Proposed Revisions to a Standard Plans Index

Index Number: 455-031

Index Title: 30" SQUARE PRESTRESSED CONCRETE PILE -
HIGH MOMENT CAPACITY

LAST REVISION 11/01/22	DESCRIPTION:	FDOT FY 2023-24 STANDARD PLANS	30" SQUARE PRESTRESSED CONCRETE PILE - HIGH MOMENT CAPACITY	INDEX 455-031	SHEET 1 of 1
---------------------------	--------------	--------------------------------------	--	------------------	-----------------

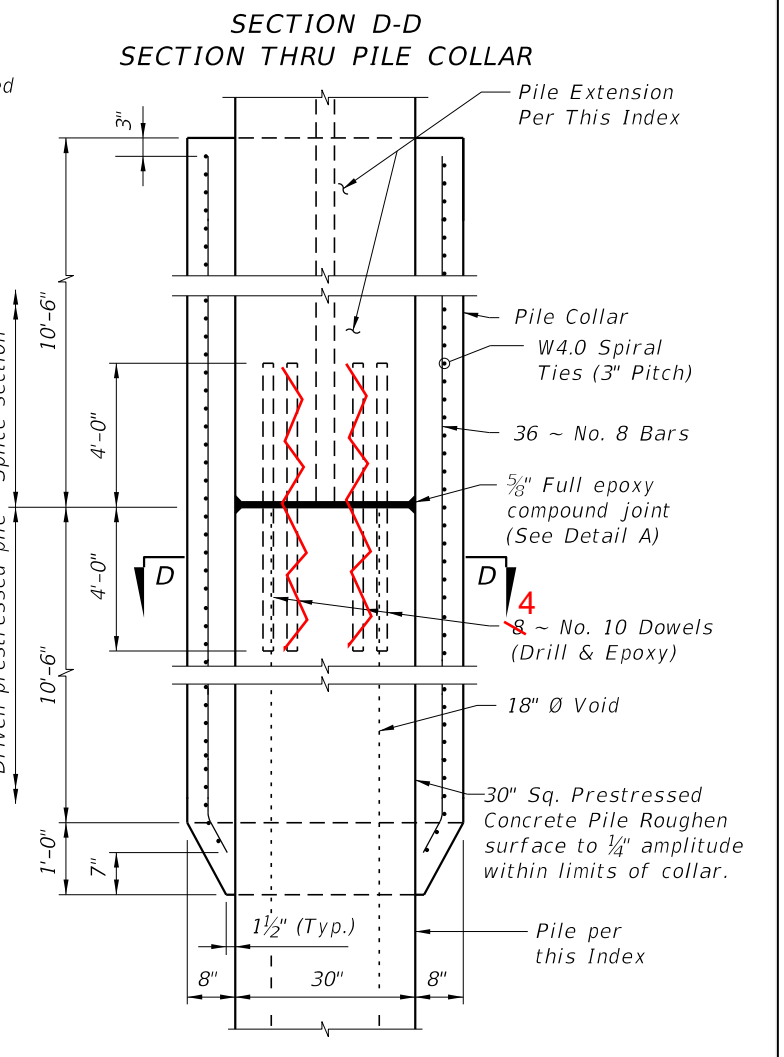
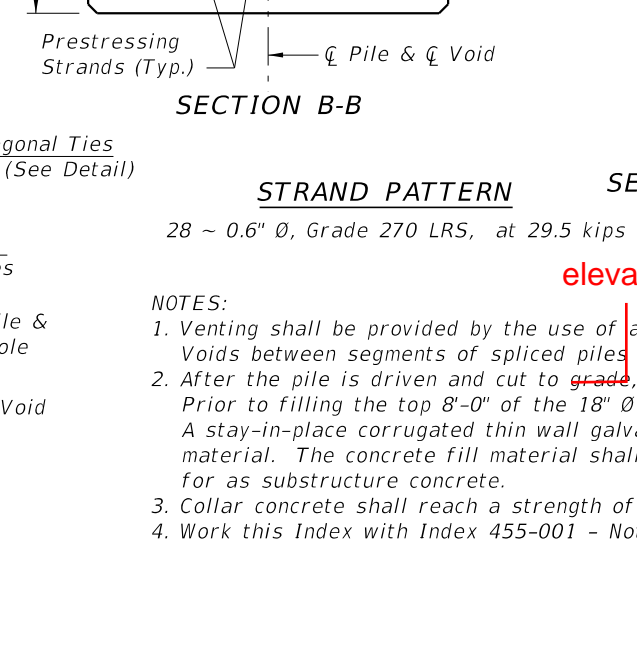
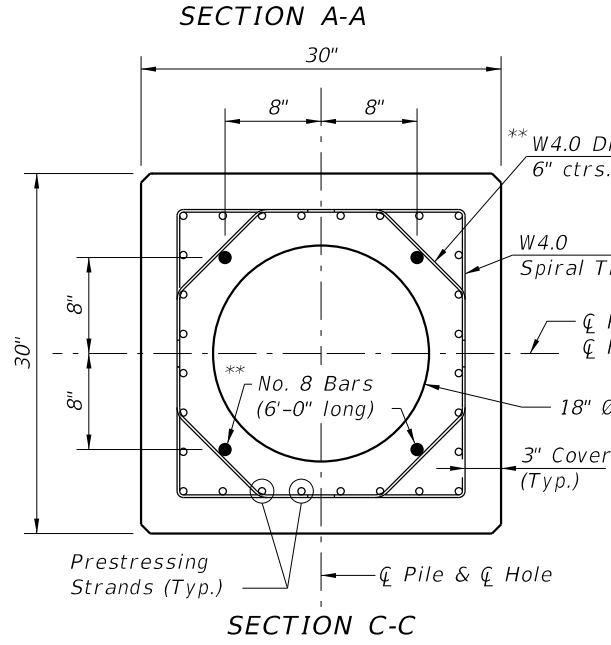
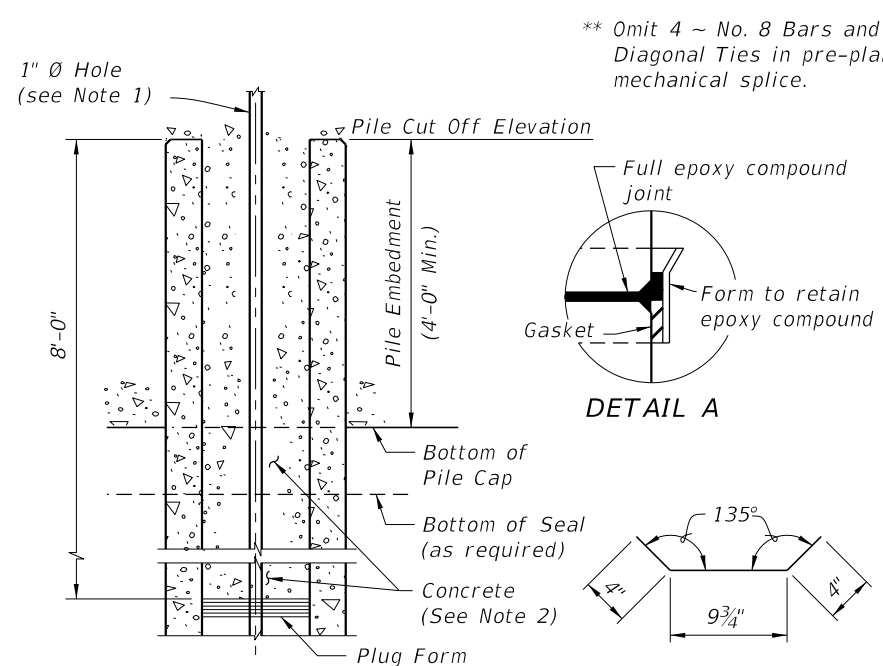
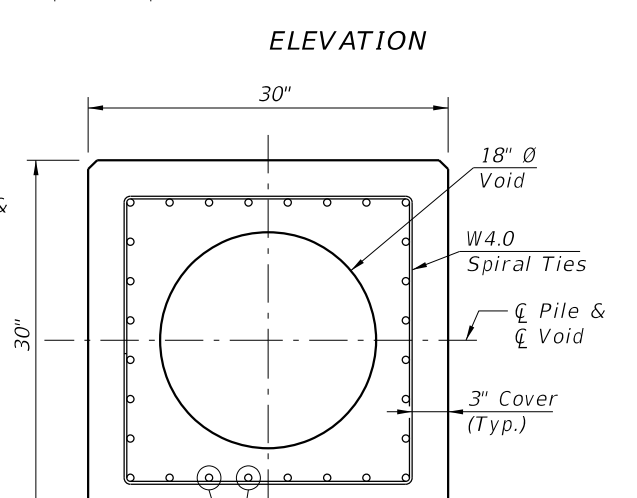
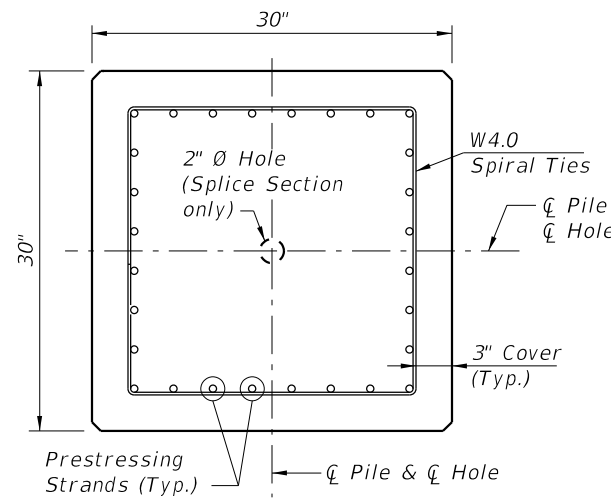
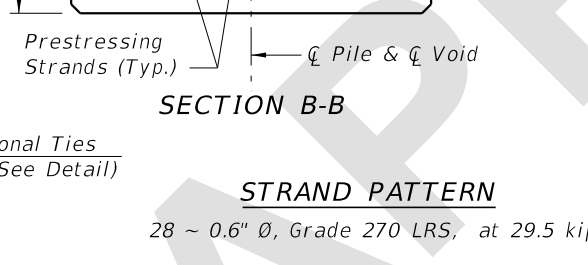
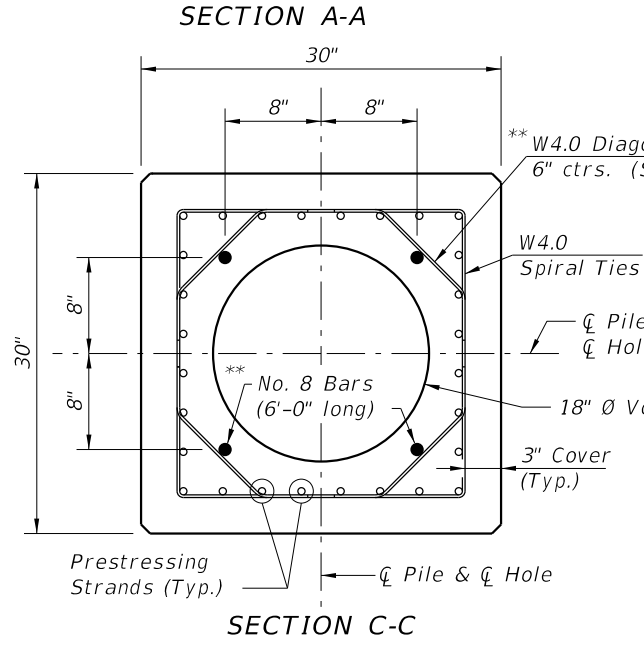
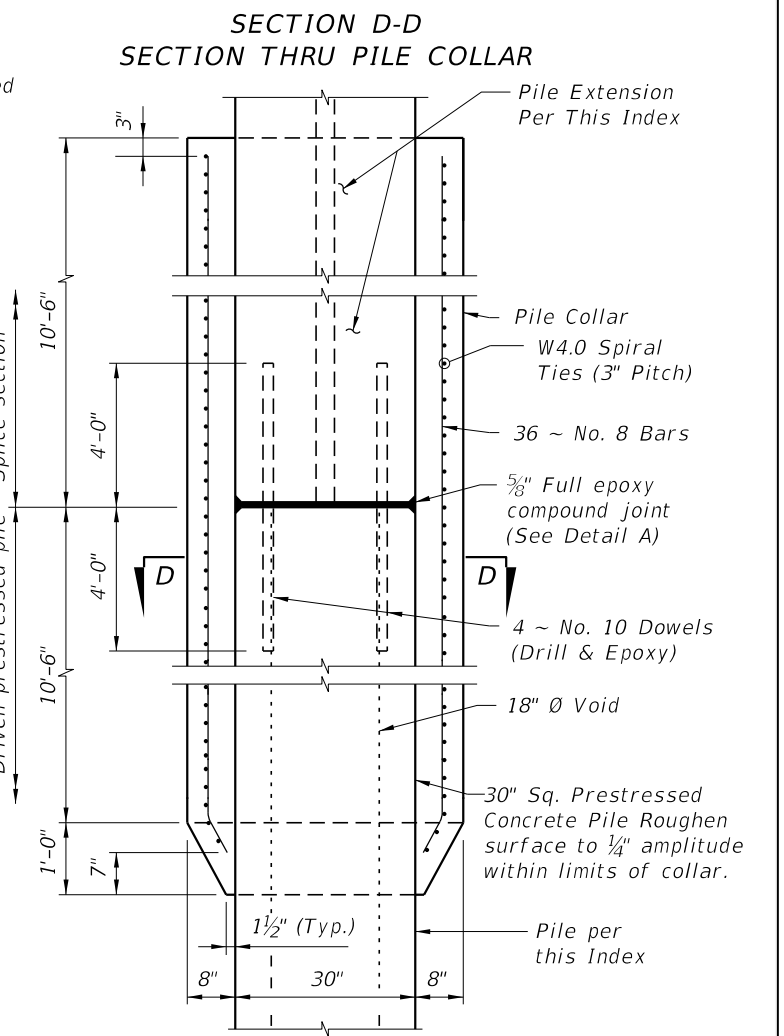
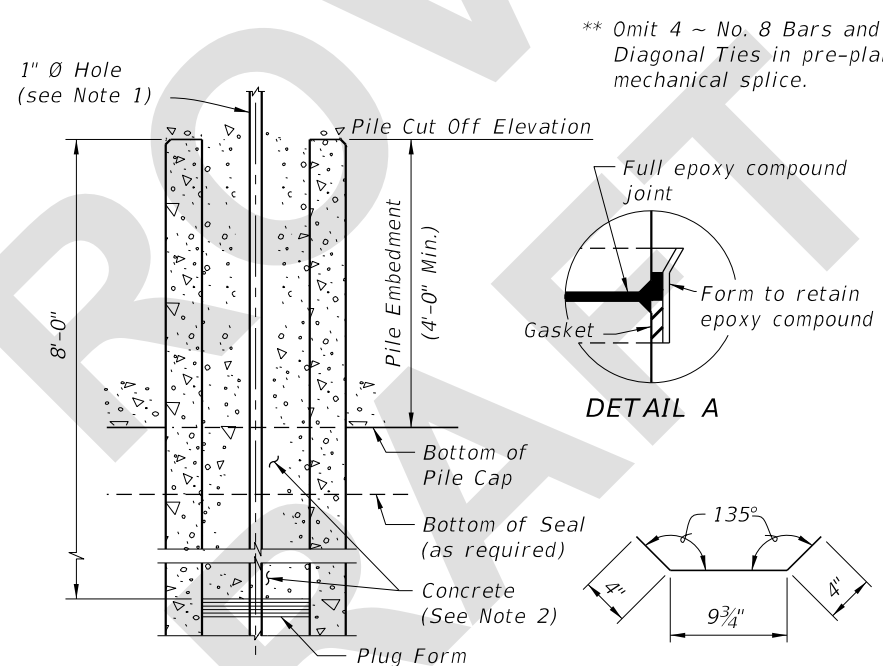
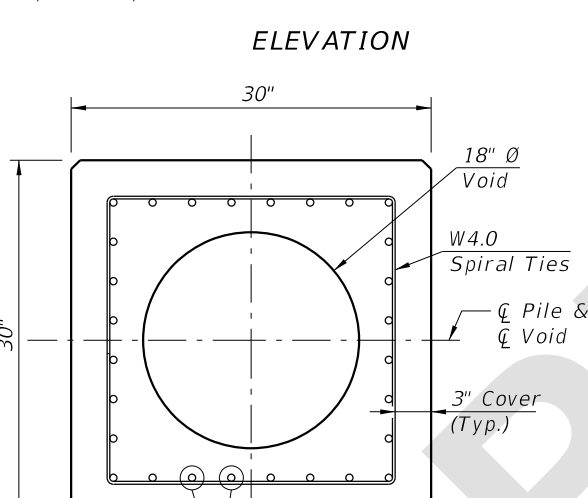
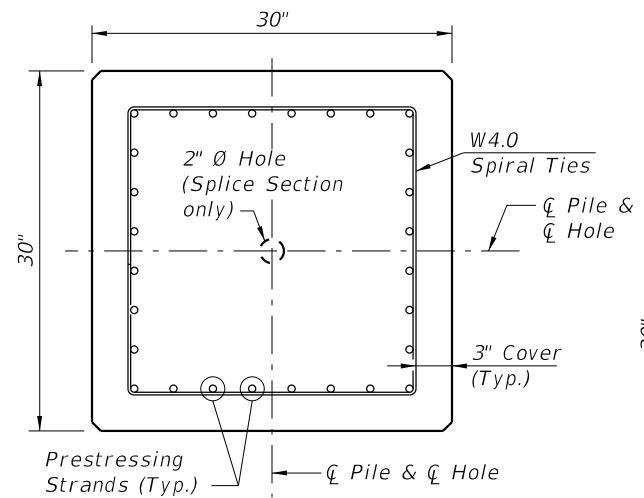
Sheet 1: Changed the location of the dowels; Deleted part of note 2 not allowing for corrugated galvanized metal pipe forms.

The location of drilled holes for the #10 dowels that are epoxied into the voided end for the splice connection are extremely close to the face of the void and will spall during drilling (1-3/4" drill bit).

These dowel bars should be moved further inside the pile wall, but the only place to avoid other reinforcing is inside the corner of the strand pattern (see the blue circle in the markup below). This would reduce the total number of dowel bars possible from 8 to 4, but this should be OK since almost all the moment capacity comes from the collar reinforcing (36~ #8 bars on the perimeter) recognized these extend lapped 10-feet either side of the splice joint while the #10 dowel bars only extend 4-feet and are temporary restraint and alignment while the exterior collar is constructed. -- Steve Nolan

For the metal pipe forms it was decided that the forms would create a corrosion risk and reduce the possible lifespan of the pile. Therefore, this allowance was removed.
